Access Compliance Report Public Rights-of-Way (Pedestrian Signals)

Main Street: MESA_DR Cross Street: IRVINE_AVE Location: NW

ADA ID: SGAT220128113942 Signal Type: One Push Button-Non APS Overall Compliance: No Severity Scores: BTN 1: 35 BTN 2: N/A No BTN: N/A

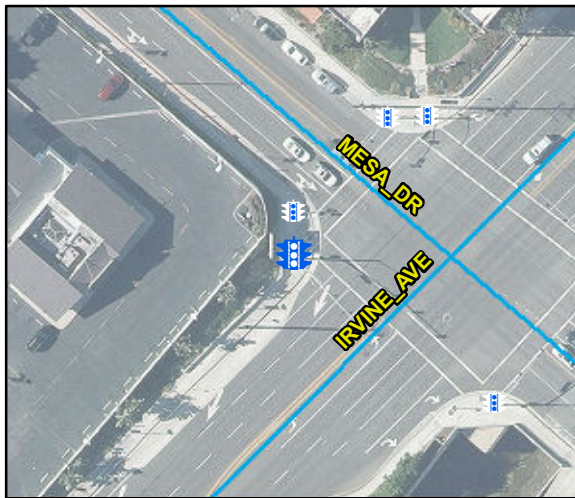
Possible Solutions: Replace Signal Push Button With APS Button. Remove and Replace Clear Space.

OC Std/PROW: R404.2, R403.4, MUTCD 4e.08
